# COMMUNITY BOARD FEEDBACK PACKAGE

## DINING OUT NYC

**Business Name:** 8-Bit Bites

**Cafe Address:** 193 7 AVENUE, NEW YORK, NY, 10011

## SECTION 1: Site Plan

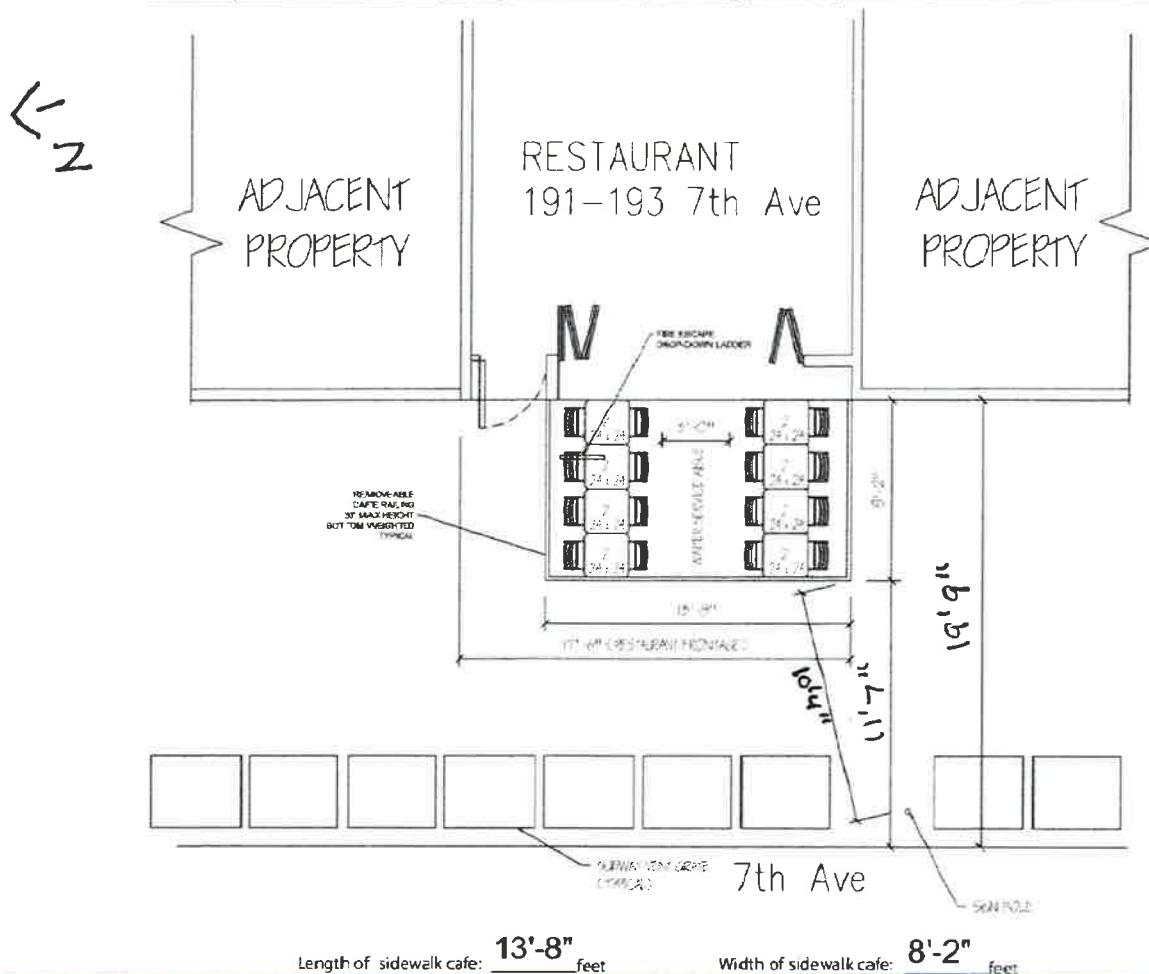
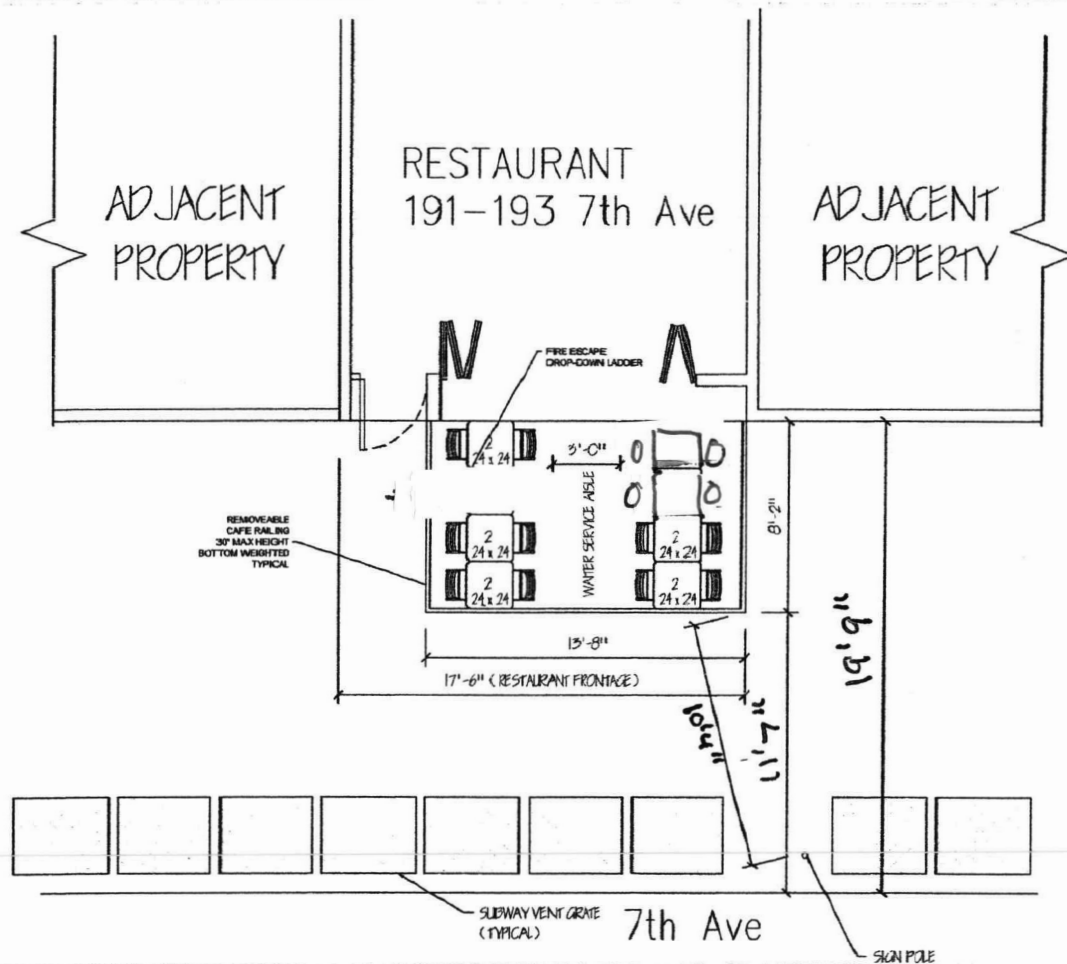
The proposed Site Plan includes a table under a fire escape. To clear the fire escape, the applicant has agreed to remove one table with two chairs and has provided the attached Revised Site Plan.

To clear the fire escape, MCB4 requests that one table with two chairs be removed from the proposed Site Plan.. Applicant has agreed to this modification and has provided the attached Revised Site Plan.
